DOCUMENT CHANGE REQUEST

DCR number 497	Changes required for: General	Originator: S Jeffery - ESCC
Date: 2009/04/14	Date sent: 2009/04/14	Organisation: ESA/ESTEC
Status: IMPLEMENTED

Title:	Transistors Low Power PNP, based on type 2N2905A		
Number:	5202/002	Issue:	2

ESCC Detail Specification No. 5202/002

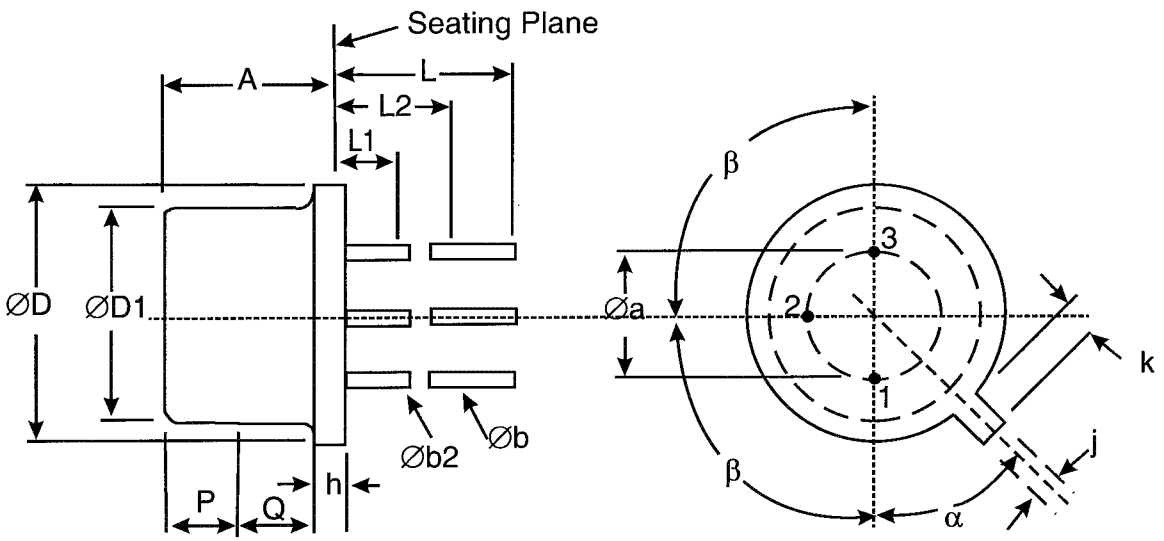
Characteristics	Symbols	Maximum Ratings	Unit	Remarks
Collector-Base Voltage	V_{CBO}	-60	V	Over entire operating temperature range
Collector-Emitter Voltage	V_{CEO}	-60	V	
Emitter-Base Voltage	V_{EBO}	-5	V	
Collector Current	I_C	-600	mA	Continuous
Power Dissipation	P_{tot1}	0.6	W	At $T_{amb} \leq +25^{\circ}C$ ~~Note 1~~
	P_{tot2}	3	W	At $T_{case} \leq +25^{\circ}C$ ~~Note 1~~
Operating Temperature Range	T_{op}	-65 to +200	°C	Note ~~2~~ 1
Storage Temperature Range	T_{stg}	-65 to +200	°C	Note ~~2~~ 1
Soldering Temperature	T_{sol}	+260	°C	Note ~~3~~ 2

see attached

make o bigger

~~1. For T_{amb} or T_{case} > +25°C, derate linearly to 0W at +200°C.~~

1. ~~2.~~ For Variants with tin-lead plating or hot solder dip lead finish all testing performed at T_{amb} > +125°C shall be carried out in a 100% inert atmosphere.
2. ~~3.~~ Duration 10 seconds maximum at a distance of not less than 1.5mm from the device body and the same lead shall not be resoldered until 3 minutes have elapsed.
